APPEAL TO THE BOARD OF SUPERVISORS
COUNTY OF SANTA BARBARA

RE: Project Title Largura New Residence, Guesthouse, and Grading

Case Number 07CUP-00000-00336, 07BAR-00000-00129, 07APL-00000-00035

Grounds for Appeal
Largura Residence (07LUP-00000-00336)

Project Changes

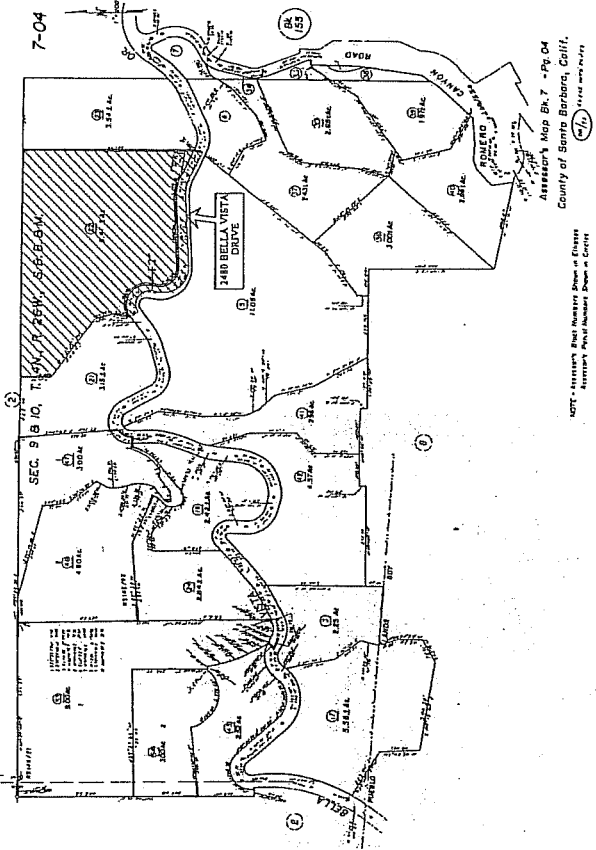
In response to comments from the Commission at the December 19, 2007 meeting, the applicant submitted revised plans on January 7, 2008. Staff has reviewed the revised plans (see attached) and noted the following changes:

- a. On the south facade, replaced the proposed plaster arched arcade loggia with a stone column pergola and wood trellis.
- b. Reduced traditional retaining walls through the use of boulder retaining walls and alterations to proposed fill placement, including a reduction of 15 cubic yards of fill. Retaining walls now consist of 295 feet of boulder walls from 1-4 feet high and 65 feet of traditional retaining walls of no more than 4 feet high.
- c. Lowered the infinity pool pad and reduced infinity trough by 18 inches.
- d. Altered the landscape plan follows:
 - Relocated one 48 inch tree to be adjacent to the infinity pool.
